S E R V I C E N O T E

J2522B Internet Advisor

Possible fire hazard

Note Drawing shown with the rear panel removed.

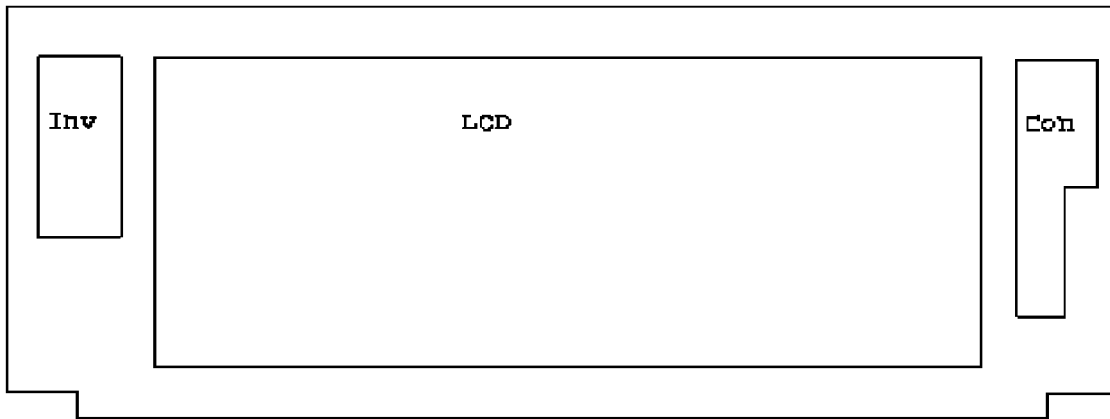
The 0950-2937 Display Board Inverter Assembly installed into the J2522B display does not meet Agilent's Fire Retardant standards and should be replaced. Inverter boards 0950-2937 marked with LOT 56 on the transformer in instruments with the serial number listed should have this modification to prevent instrument damage.

1. Remove the back panel from the display by removing 6 painted screws.
2. Locate 0950-2937 (note drawing marker “Inv”), remove 2 screws and cables from the board and remove the inverter board from the display assembly.
3. Replace the board with 0950-2937 with different LOT number.
